Fuel Storage Tank Installation West Energy Plant University of South Carolina State Project Number H27-Z228

Addendum Three

October 26, 2016

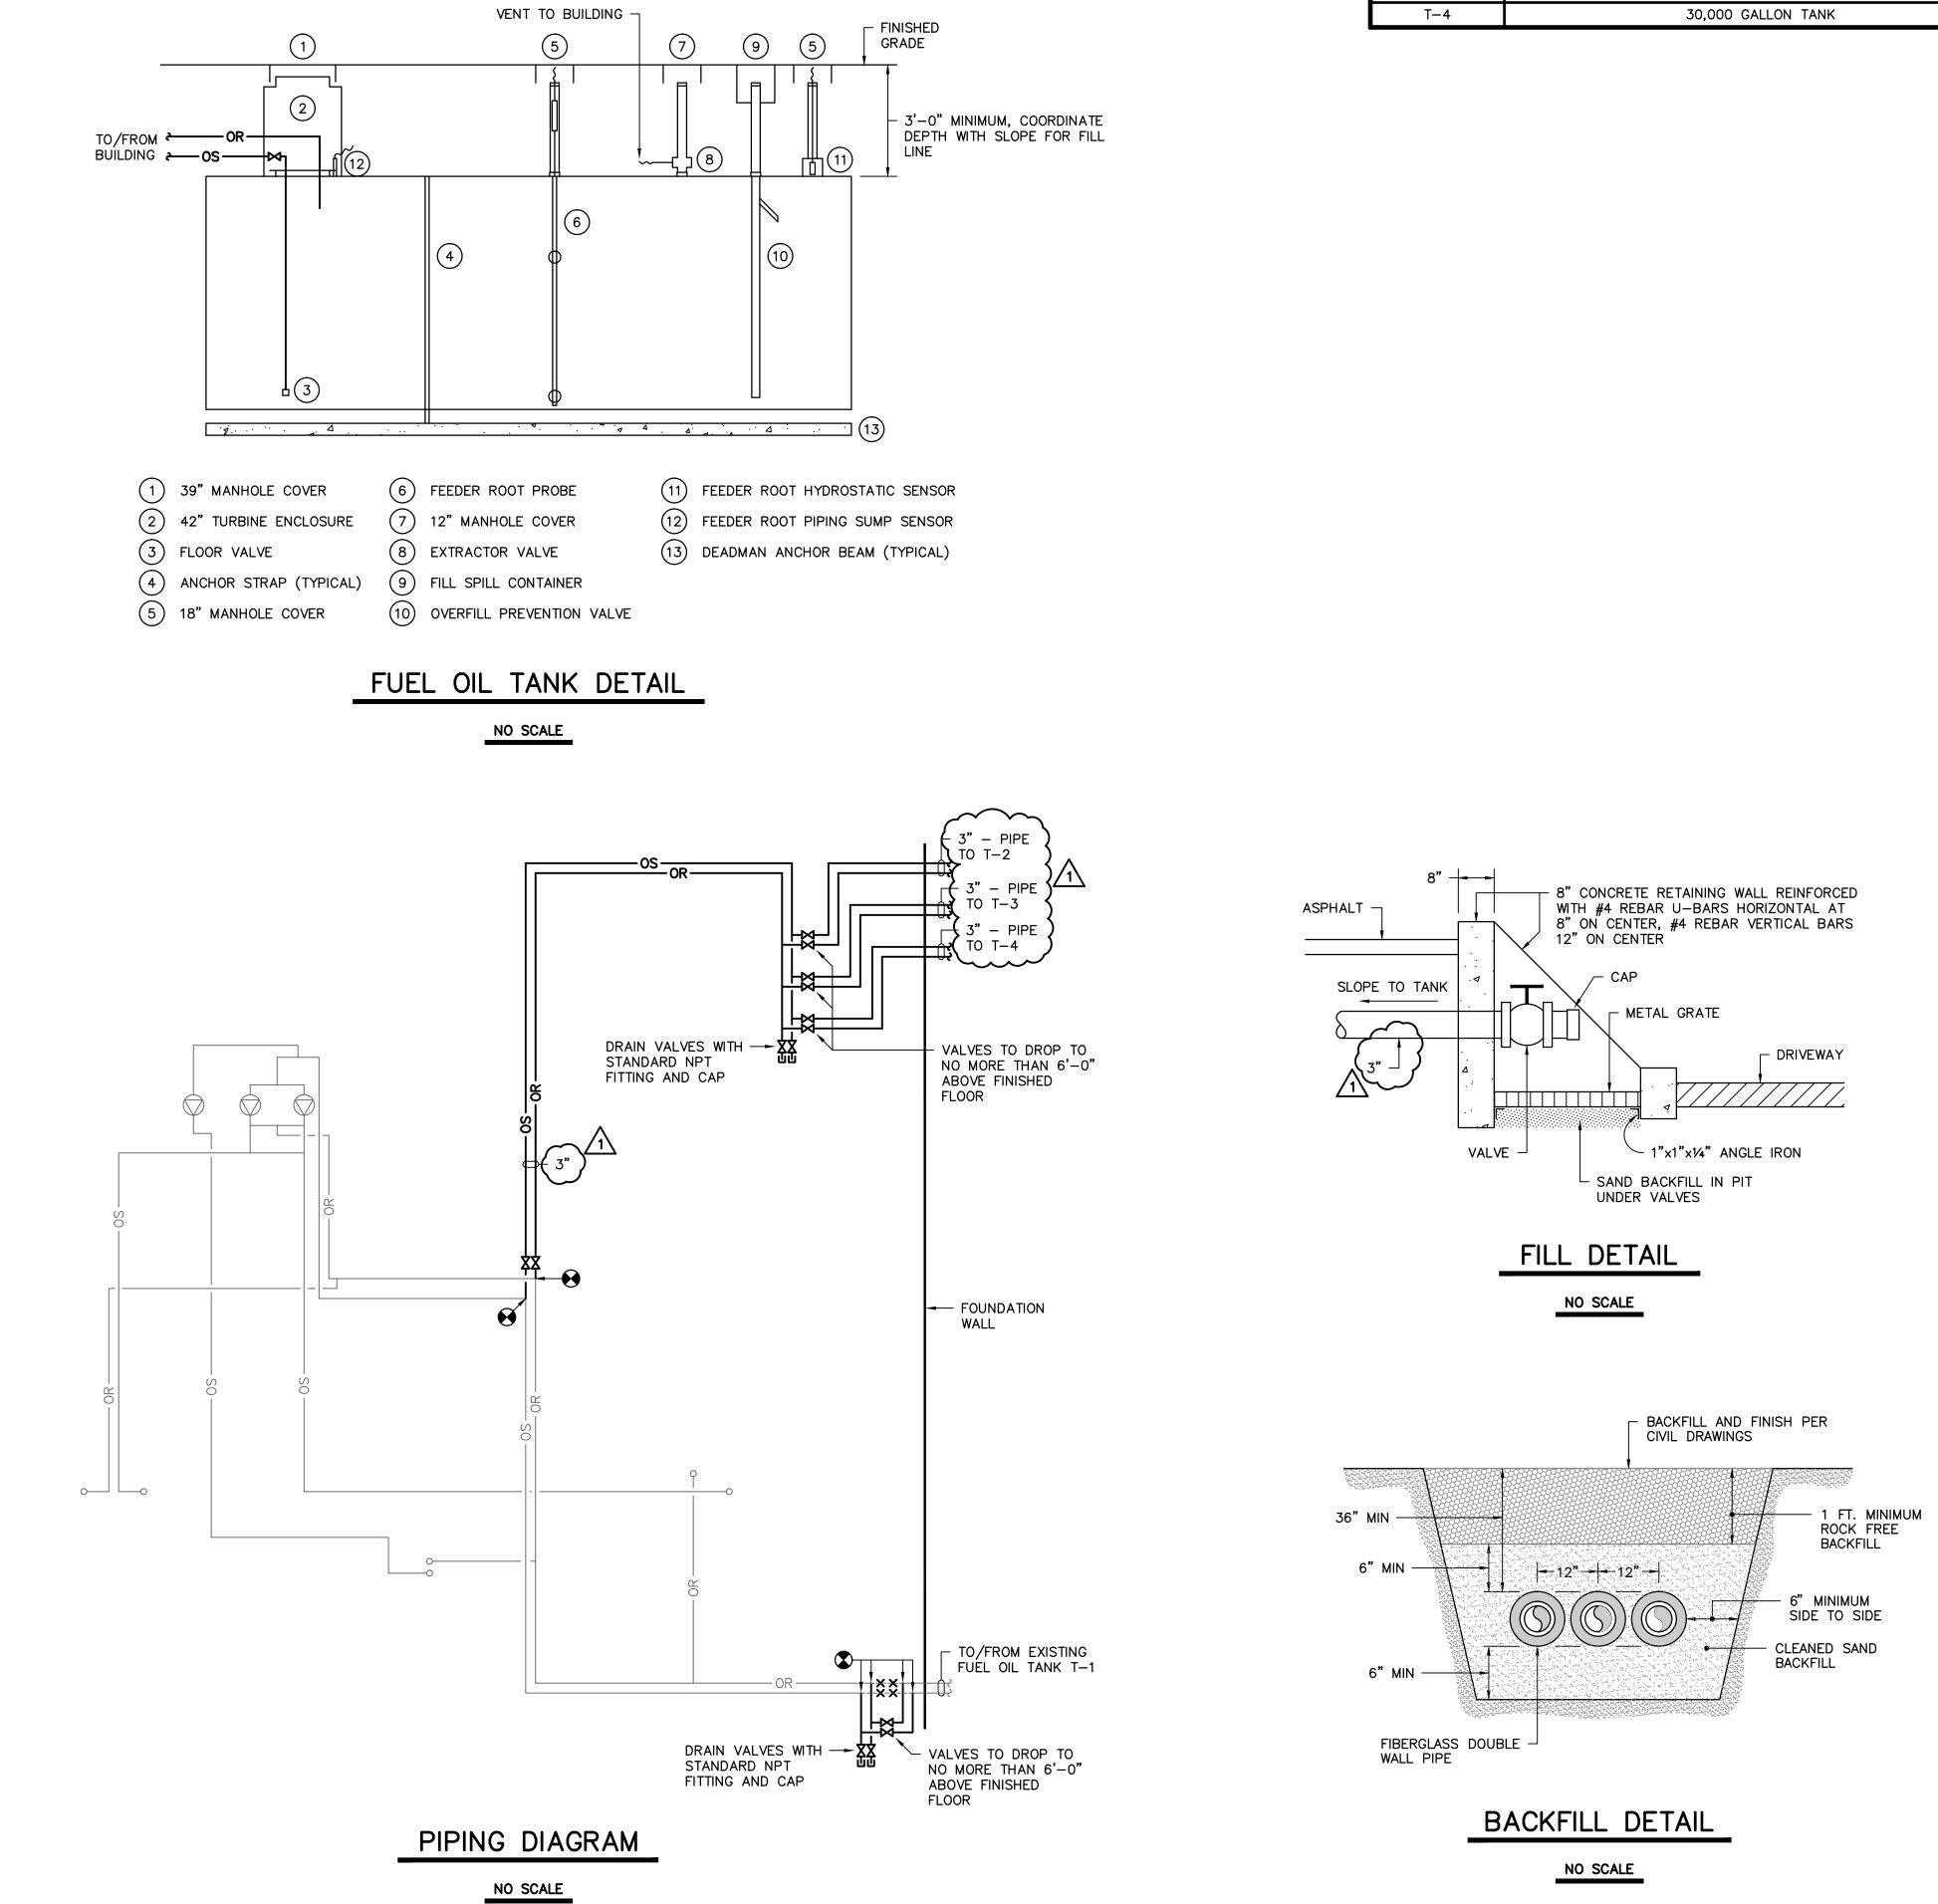
- 21. <u>Revision:</u> Reference Drawing M1, Site Plan. Change the pipe size for the fill lines from 2" to 3". Change the size for the oil supply and oil return pipe to the tanks from 2" to 3".
- 22. <u>Revision:</u> Reference Drawing M1, Site Plan. The vent location shown should indicate that three vents are located here, one separate vent pipe for each tank.
- 23. <u>Revision:</u> Reference Drawing M3, Details and Notes. The oil supply and oil return pipe sizes have been changed to 3".
